**BOARD OF ZONING ADJUSTMENT
STAFF REPORT**

5708/5685

Advanced Disposal Services Gulf Coast, LLC & Jeffrey E. Quinnelly

6225 Rangeline Road
(East side of Rangeline Road, 1400'± North of Old Rangeline Road).

SITE PLAN

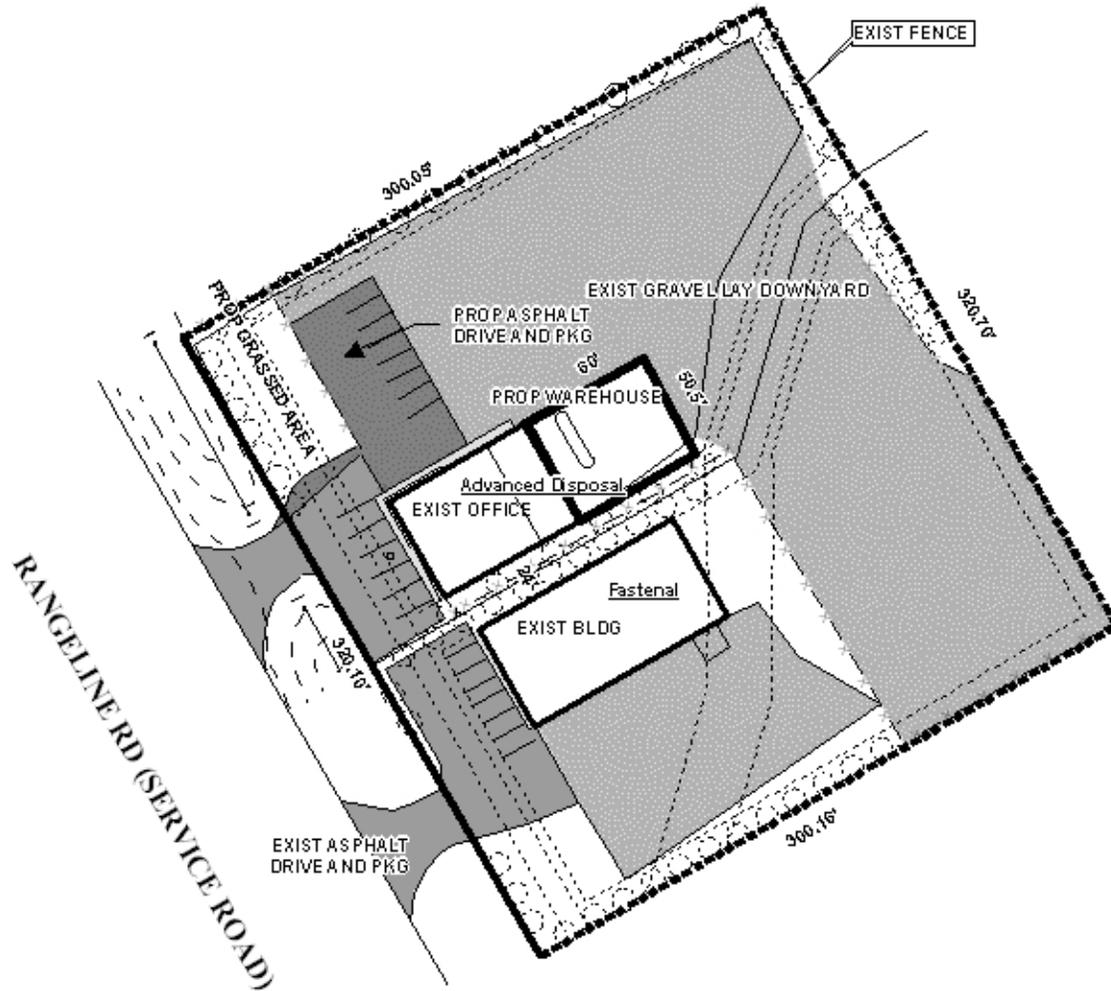
The northern most parking stall needs a slip to allow the motorist room to back out and exit the parking lot headlights first. If you will be working in the roadway or performing any activities that will affect traffic, you must submit a Traffic Control Plan at least two working days prior to proceeding.

photographs do not indicate any gravel surfacing in the area of the proposed off-site parking at 6235 Rangeline Road, and the site plan indicates existing gravel within that area. Also indicated on the site plan and seen on recent site photographs is an un-permitted fence around the expanded gravel parking compound. The applicant was granted a sidewalk waiver for 6225 Rangeline Road at the July 7th Commission meeting.

The site plan submitted indicates seven additional proposed standard vehicle parking spaces on the applicant's site which would meet the minimum parking required for the site. There is sufficient area between the proposed new parking and the front of the property to provide at least as many more parking spaces with compliant access/maneuvering area and would allow the existing noncompliant access/maneuvering parking area directly in front of the building to be replaced with landscaped area. Therefore, the site does not impose a hardship which would prevent compliant standard vehicle parking to be provided.

The Front Landscaping Variance request pertains to the 6235 Rangeline Road site as it is approximately 308 square feet deficient in meeting the required total frontage landscaping of 3,640 square feet for that site. Technically, as no building expansion is proposed for that site, landscaping would not normally be required; but due to the fact that the site is an extension of a site requiring landscaping compliance, such compliance should also apply to the adjacent site. Since staff feels that the off-site parking issue could better be addressed via a PUD, landscaping compliance would be required and can be achieved. The sum of the total frontage landscaping requirements of both sites could be applied to the PUD as a whole, and there is sufficient area on the applicant's site, even with the suggested increase in the proposed standard vehicle parking area, to combine with the deficient area on the adjacent site, to meet the over-all requirements of frontage landscaping for a PUD.
